## Technical Tip

**Model:** HTR-330/530, TX-SR303/SR503

**Subject:** General troubleshooting for Protect problem.

## Service Bulletin

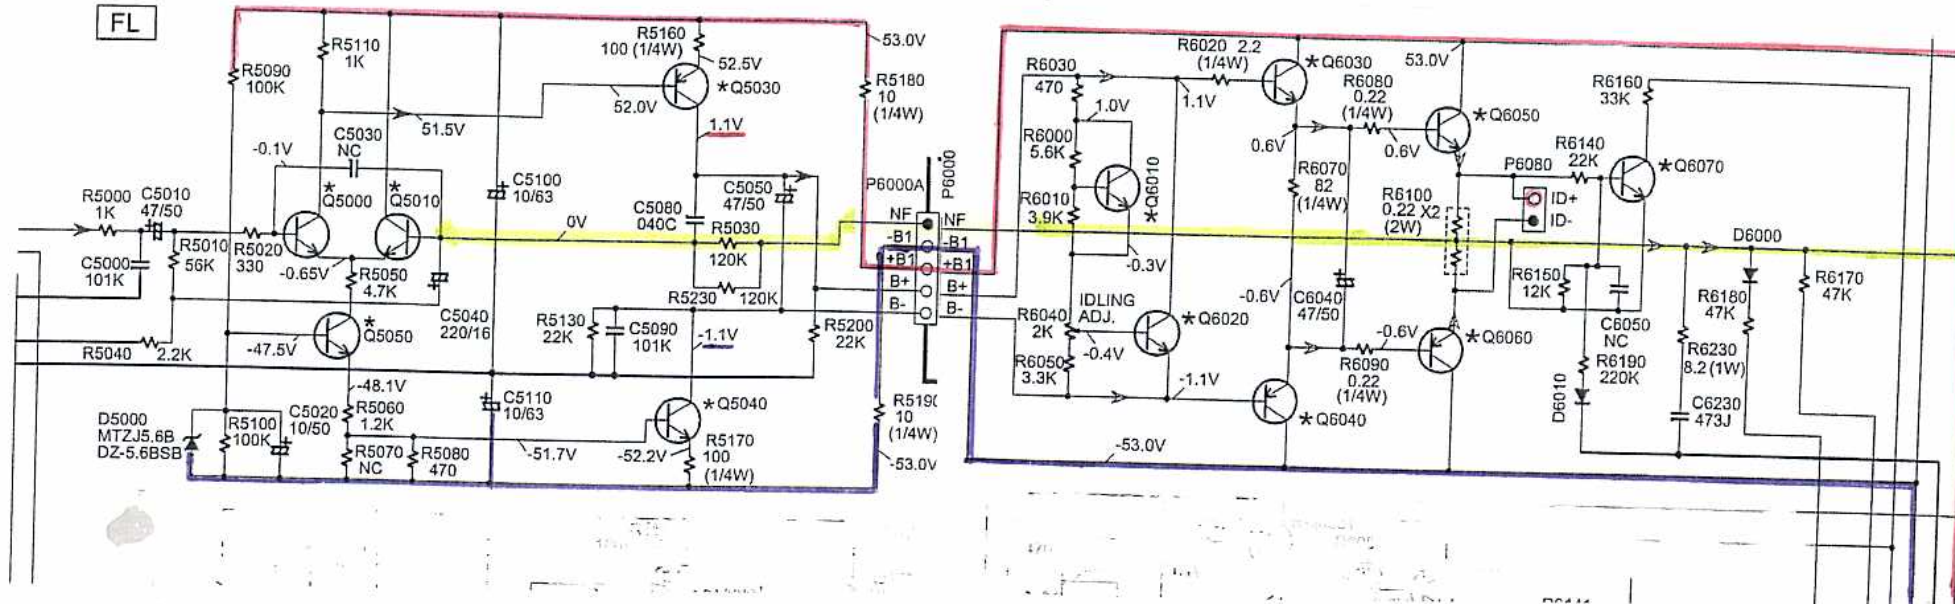
- 1 . Normal audio using analog inputs. Do you have all Dolby surround sound ?
- 2 . All DSP voltages are normal ? Did all supply voltage go to all ICs ? +5vDSP, 2.5V, +3.3V... +7v, -7V..
- 3 . Input sel IC. Use CD analog input audio signal (ADRT+, ADRT- and ADLT+, ADLT-) out to DAC IC ?  
Surround analog signal out (DAC L, DAC R, DAC C, DAC SW, DAC LS, DAC RS, DAC SB\* back to Input sel. IC.  
Pin 1 to pin8 out to p5504. ( Same as pre out) check Mutting transistors Q5600 to Q5617 .
- 4 . When use digital input signal did digital light up on display ?  
If missing 3.3v, 2.5v 5vdsp (on Reg IC Q5640) to DSP ICs will disable DSP function. (U05 Amplifer PC board)

Please use TX-SR502 as sample Technical Tip Troubleshooting.

When you need Tech help Please use Tech Email and give us Voltage and signal info. What voltage on DSP ICs and where you lost audio signal ? What you have on input IC Data line  
Check with TX-SR502 Troubleshooting tips for the Microprocessor and Audio Select IC

**Model:** TX-SR602/702/DTR-4.5/5.5/6.5

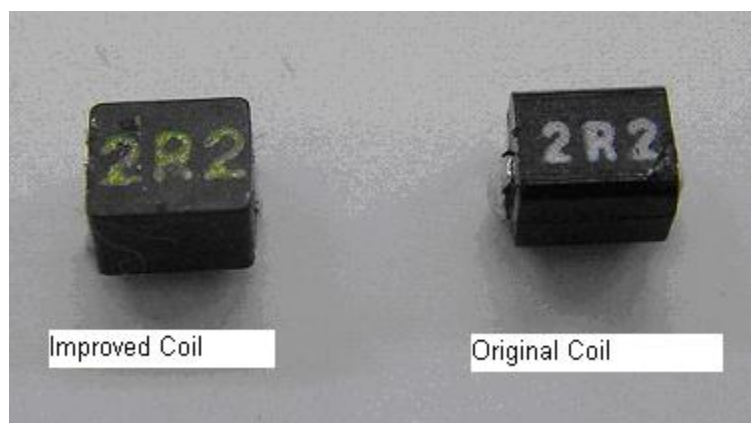
**Subject:** No sound in Surround mode

**Symptom:** No sound in Surround mode. Coil L921 which is located on the DSP board may have opened due to in rush current.

**Solution:** Check coil L921, if open, replace L921 with the improved part (green print).

Ref #	FORMER		NEW	
	Description	Part Number	Description	Part Number
L921	NCH-1587-022	233533K022R2	NCH-1471	231237M022R2
